P802.3bt D3.0 – Inrush v102

Homework: inrush cleanup.

Figure 145-23 — Per pairset inrush transient limits

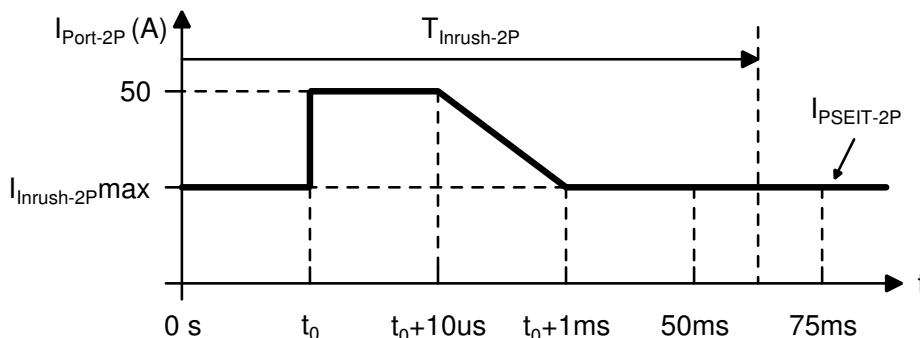
Most of the trouble with $I_{PSEIT-2P}$ is that it tries to be clever and handle pairsets and total port currents in one equation/figure. By lifting out the I_{Inrush} requirement, the need for this is gone. $I_{PSEIT-2P}$ now only needs to deal with the inrush transient. So we replace I_{max} with $I_{Inrush-2P}$.

Replace Figure 145-23 as follows:

The PSE inrush maximum limit, $I_{PSEIT-2P}$, is defined by the following segments:

$$I_{PSEIT-2P}(t) = \left\{ \begin{array}{ll} I_{Inrush-2P} & \text{for } 0 \leq t < t_0 \\ 50 & \text{for } t_0 \leq t < (t_0 + 10 \times 10^{-6}) \\ I_{Inrush-2P} + \frac{(50 - I_{Inrush-2P}) \times (0.001 + t_0 - t)}{99 \times 10^{-5}} & \text{for } (t_0 + 10 \times 10^{-6}) \leq t < (t_0 + 0.001) \\ I_{Inrush-2P} & \text{for } (t_0 + 0.001) \leq t < 0.075 \end{array} \right\}_A \quad (145-18)$$
